INITIAL FIRE SAFETY INSPECTION REPORT

JM Fabrics Ltd. (Extension 2)

RSC ID: 26564

Date: 05-March-2026

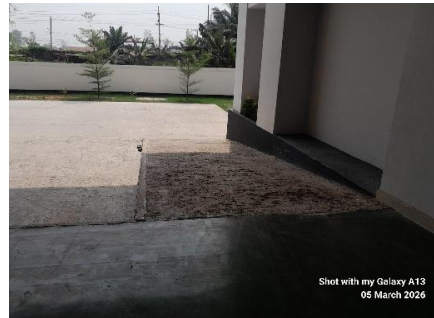
F-11	Means of Egress	Doors swing out over aisles. Location: 6th floor (Building-4).	A landing shall be provided on both sides of doors used in the means of egress to facilitate uninterrupted egress of occupants. Door shall not swing out over stairs/aisles.	Within 3 Months

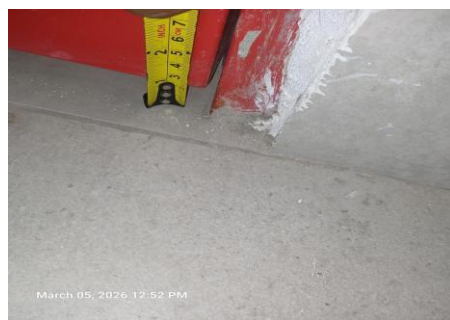
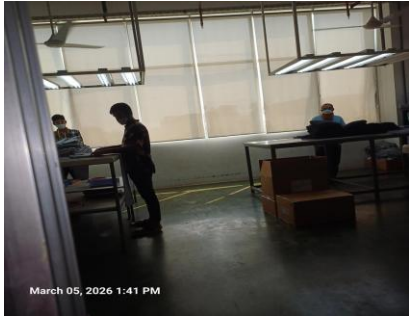
F-26	Inspection, Testing & Maintenance (Fire)	Inspection, testing and maintenance of the standpipe system are not in accordance with NFPA 25. Location: Building-4.	Inspect, test and maintain the standpipe system and keep written records on-site, in accordance with NFPA 25 and RSC Technical Guidelines (Standard) ¹ V1.0.s.	Within 1 Month (after installation)
F-27	Inspection, Testing & Maintenance (Fire)	Inspection, testing and maintenance of the sprinkler system are not in accordance with NFPA 25. Location: Building-4.	Inspect, test and maintain the sprinkler system and keep written records on-site, in accordance with NFPA 25 and RSC Technical Guidelines (Standard) ¹ V1.0.s.	Within 1 Month (after installation)
F-28	Inspection, Testing & Maintenance (Fire)	Inspection, testing and maintenance of the fire pump are not in accordance with NFPA 25. Location: Building-4 fire pump located at (Pump House Building (ID: 9497)).	Inspect, test and maintain the fire pump and keep written records on-site, in accordance with NFPA 25 and RSC Technical Guidelines (Standard) ¹ V1.0.s.	Within 1 Month (after installation)

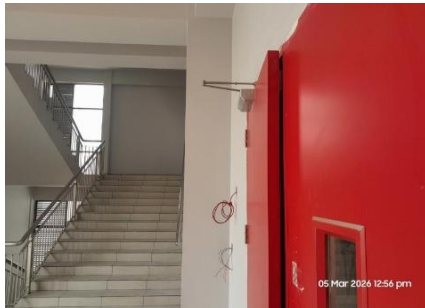
F-52	Fire Rated Construction	Penetrations through the floor/ceiling assemblies were observed to be sealed with Firestop Wrap strip. However, the required documents were not available at the time of inspection. Additionally, adequate pipe identification markings were not present on-site, preventing verification of the installed pipe type. Location(s): Plastic pipes, All floors, Building-5.	Seal all penetrations and openings in floor/ceiling assemblies by a listed through-penetration fire stop system tested in accordance with ASTM E814 or approved alternative standard to maintain minimum 3-hr fire resistance rating. Installation shall be as per manufacturer published installation guideline and the certification authority guideline to ensure the fire-rating in accordance with section 4.7 of RSC Technical Guideline (Standard) Or, Provide a minimum 2-hr fire rated shaft to separate the penetration from each floor if required.	Within 3 Months
